King Street Pump Station Improvements (Volume I) & ASR Lime System Improvements (Volume II) - RFCSP
Solicitation Number: CO-00670
Job No.: 20-6002 and 22-8603

ADDENDUM 2
October 12, 2023

D-201

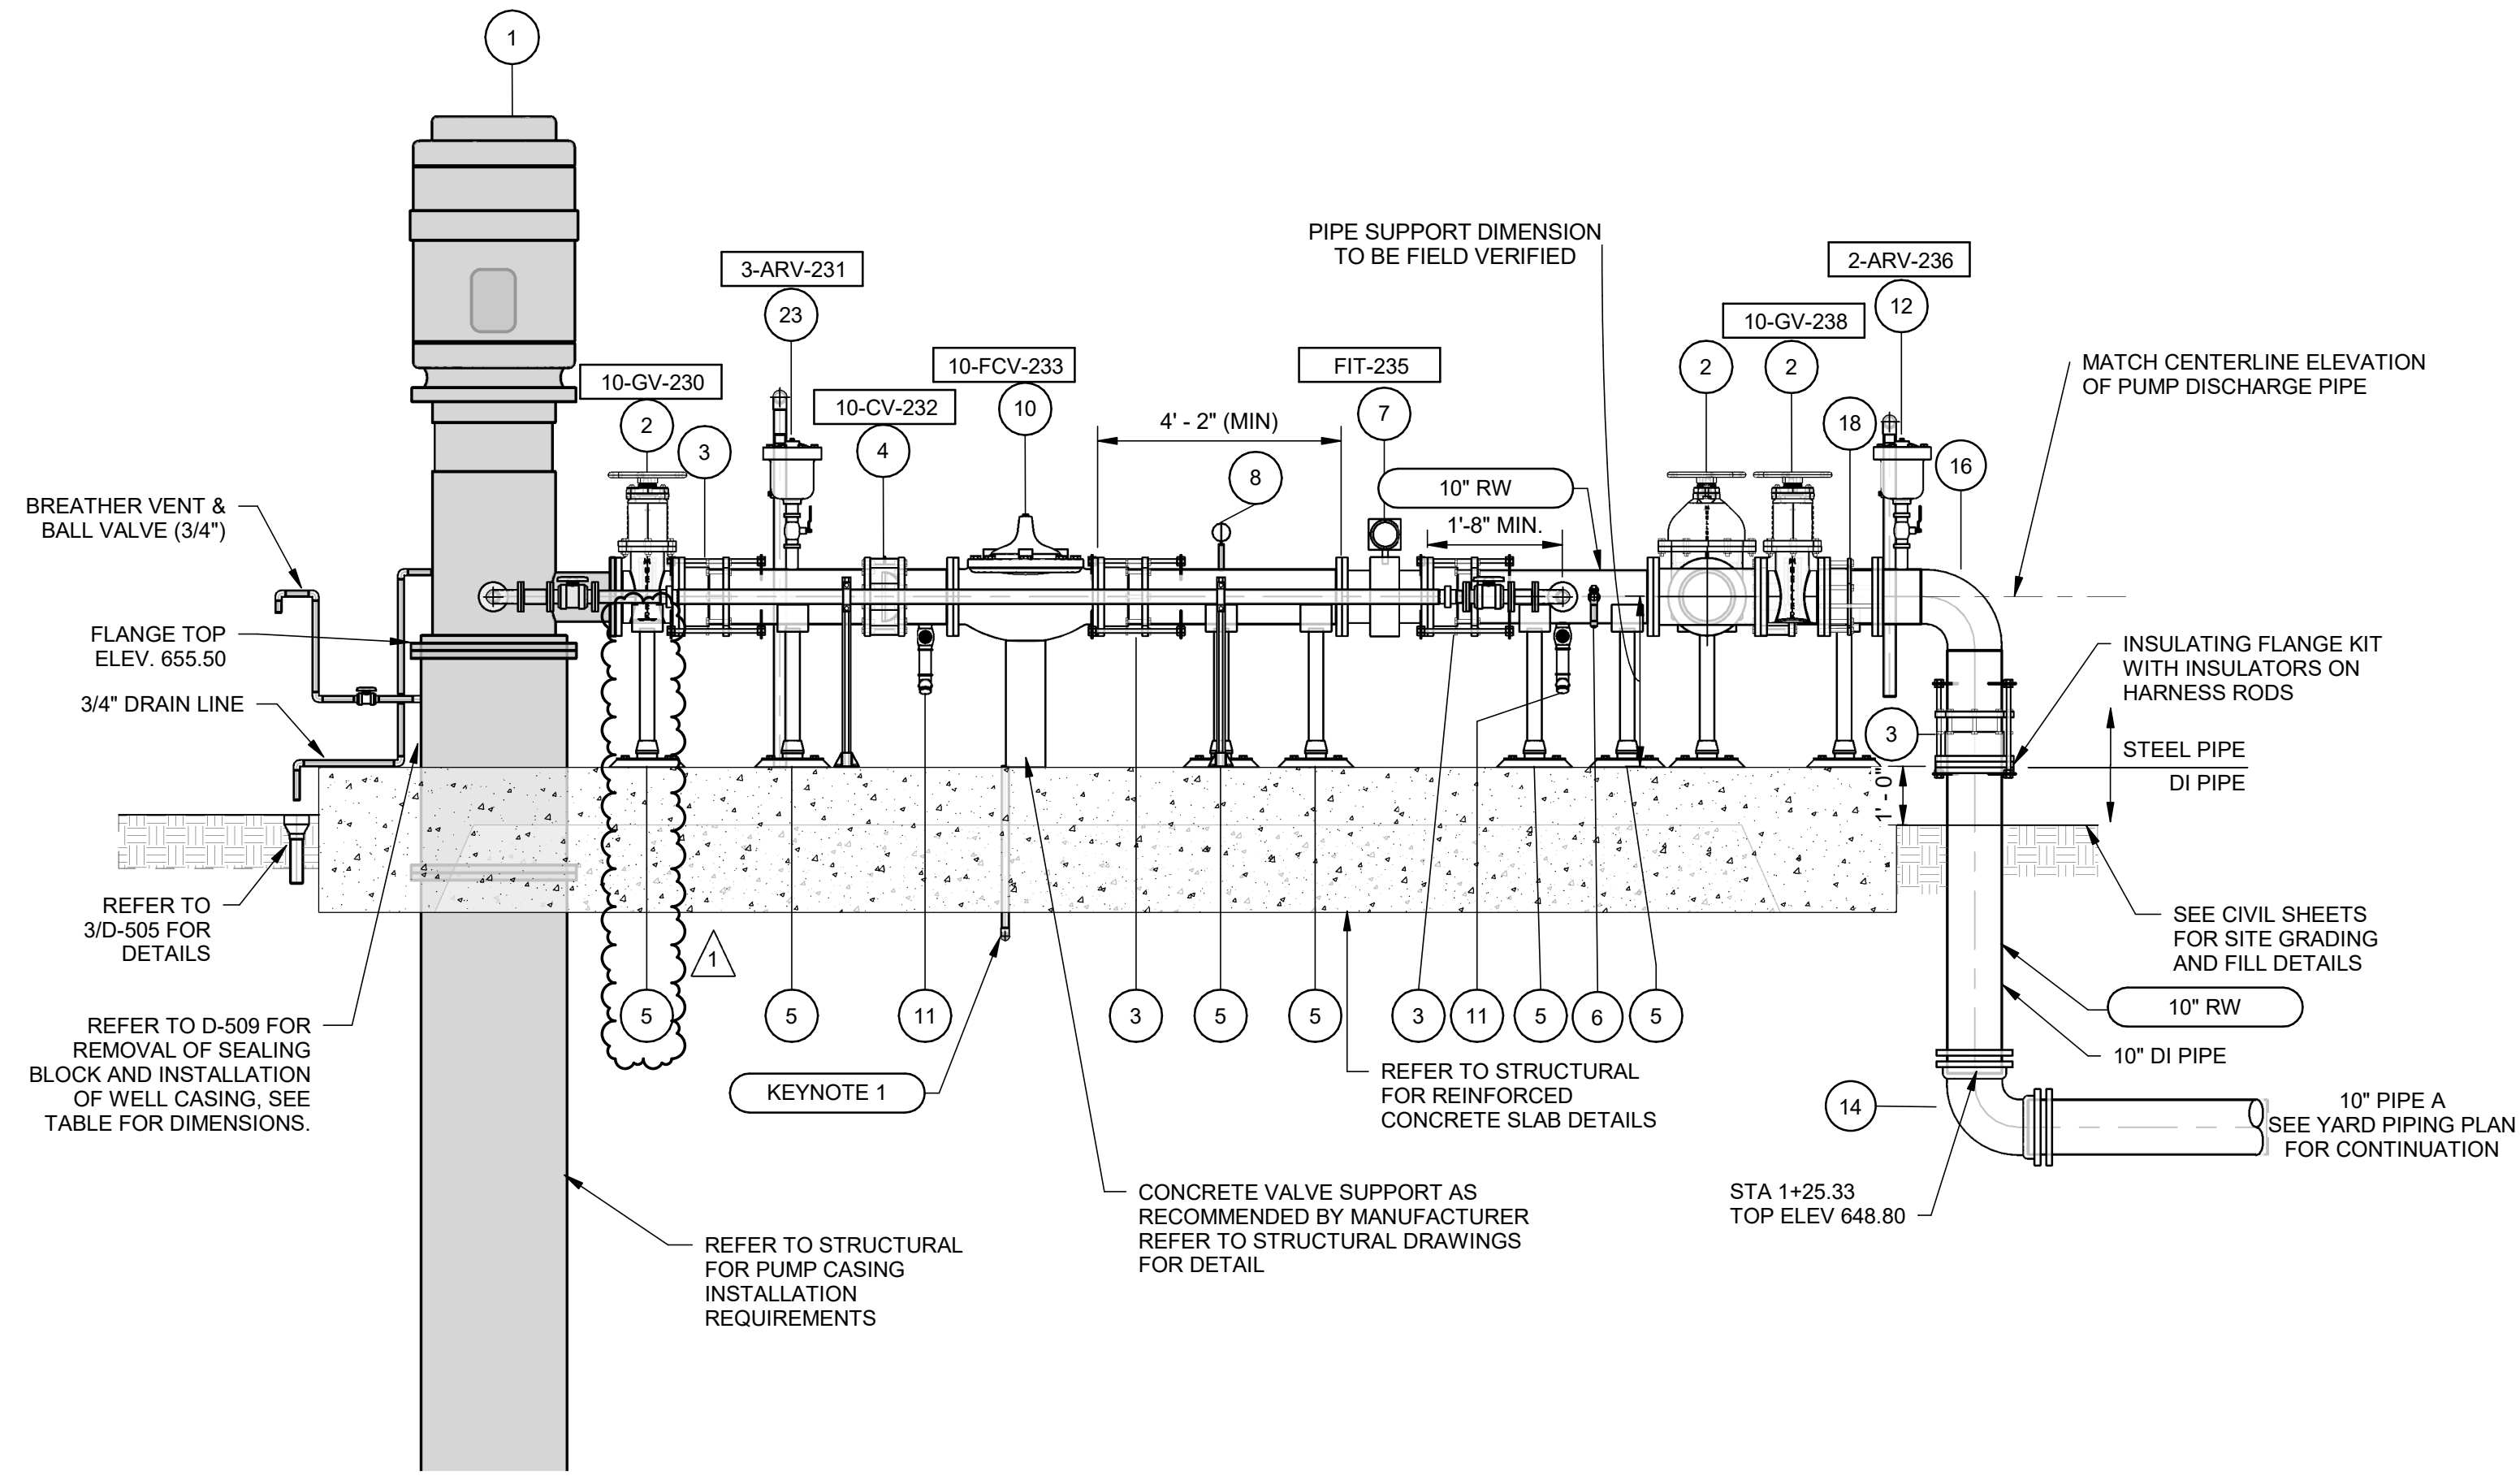
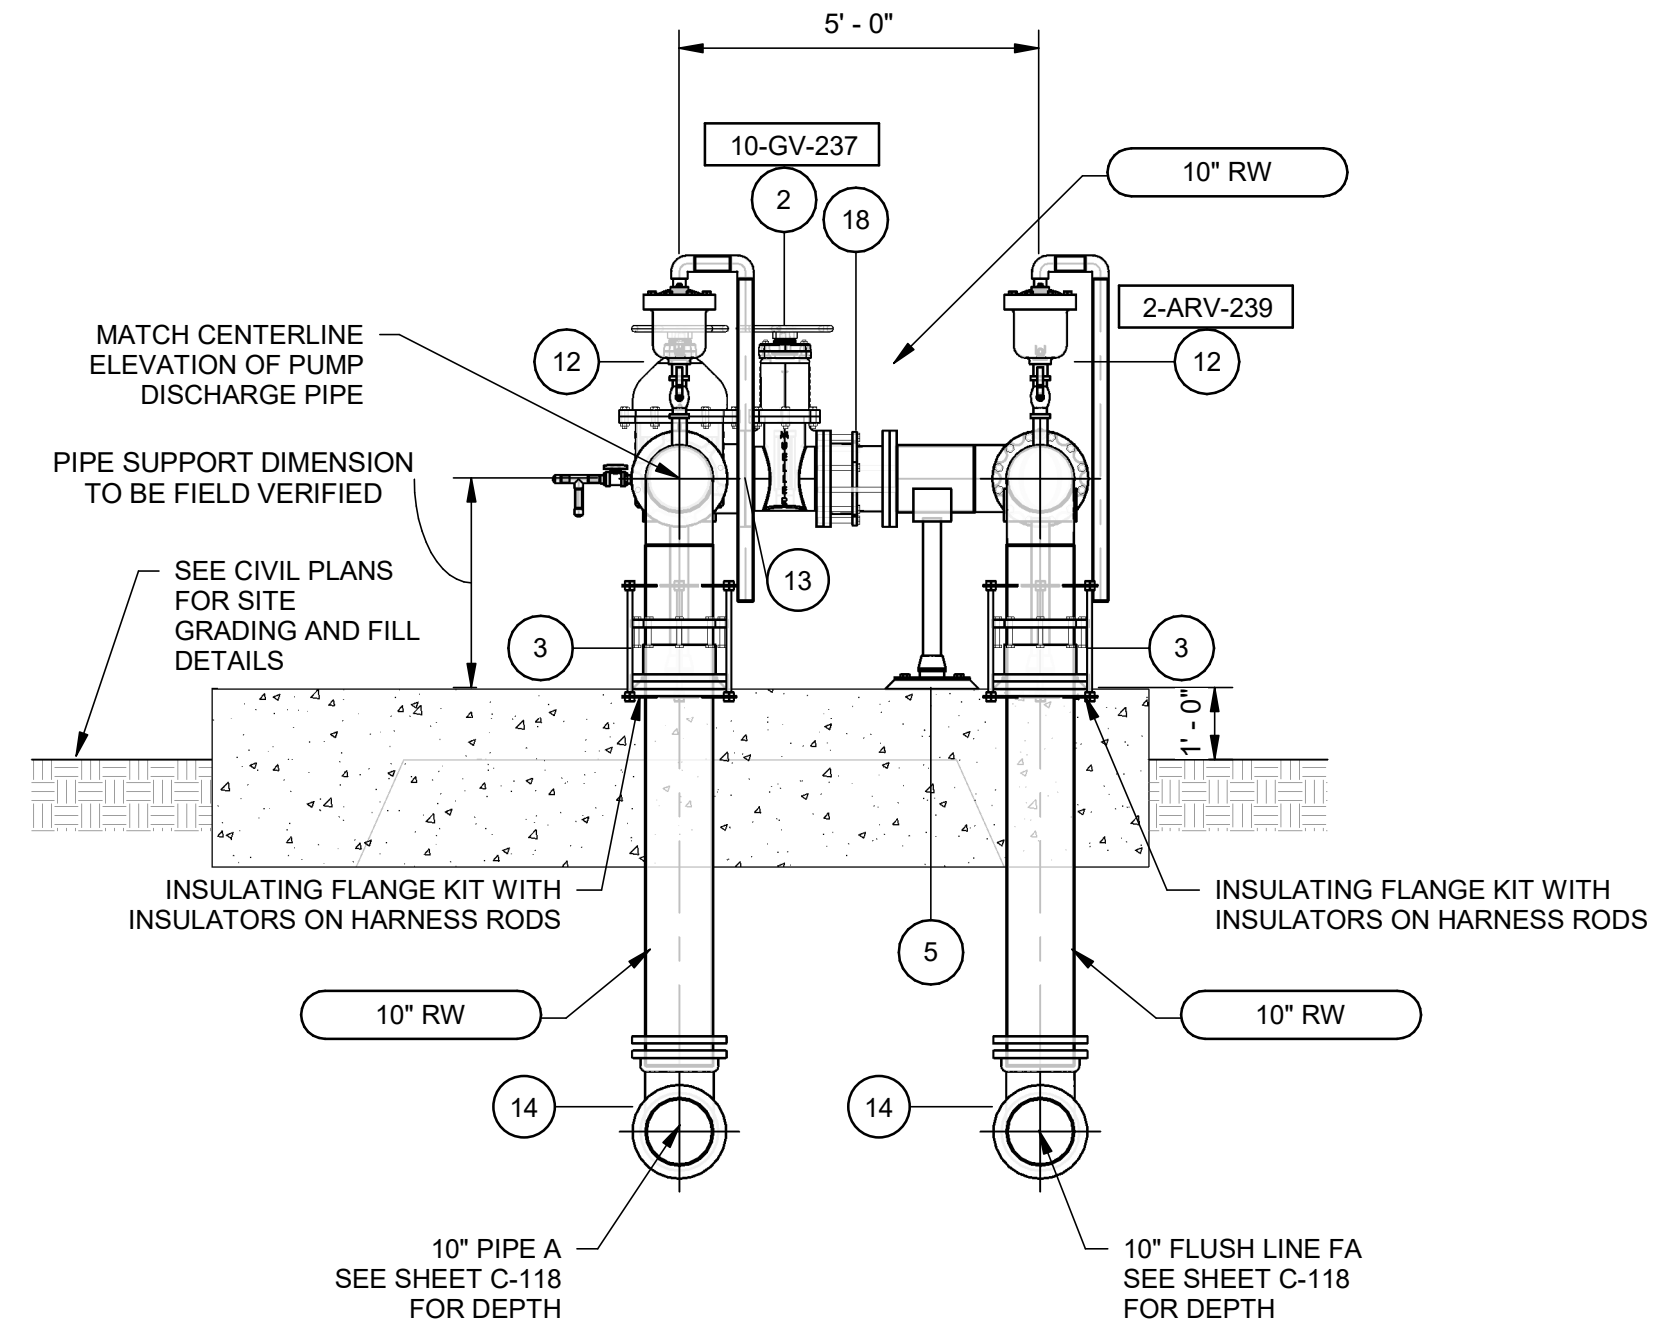
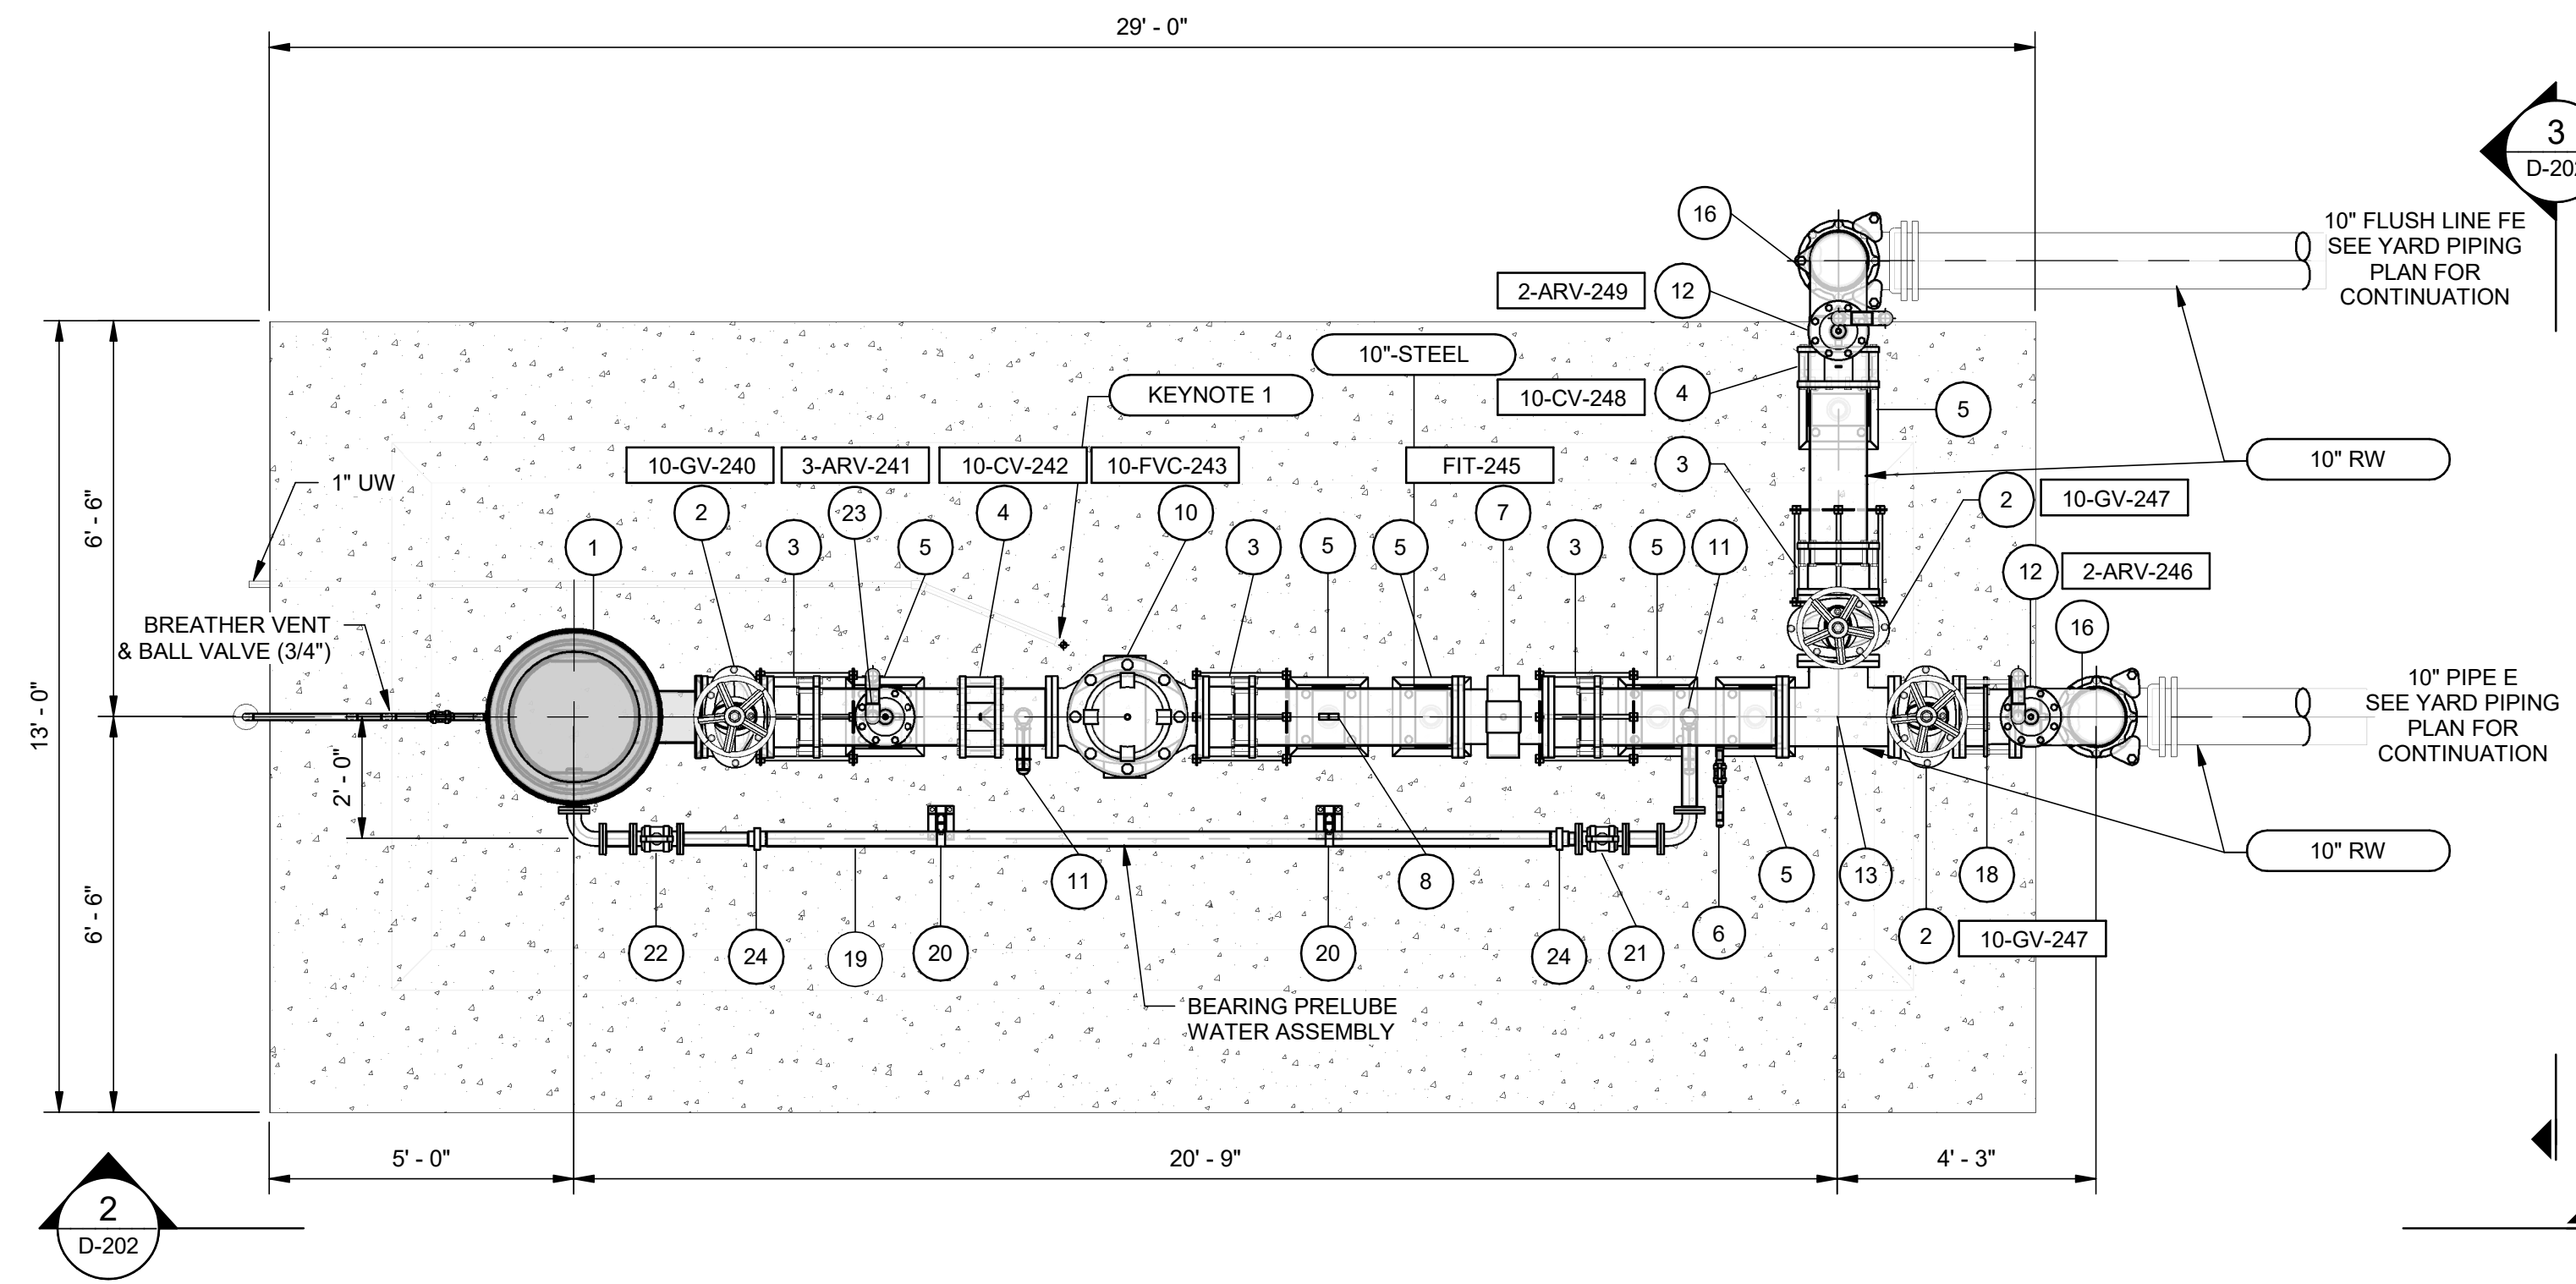
- 49. Question: Contract Drawings, Sheet D-203/204, add permanent pipe support under 12" gate valve that completely supports weight. Pump discharge should not be anchor point for any of discharge piping.**

Response: Refer to "Changes to the Plans" section item No. 3, item No. 4, item No. 5, and item No. 6 in this addendum. Pipe support added to drawings.
- 50. Question: Contract Drawings, Sheet D-203/204, add housekeeping pad/foundation around well casing pipe extended above finish floor. Surface plate assembly will be welded to well casing after installation/leveling. Grout to be poured up to bottom surface of top plate of the surface plate assembly.**
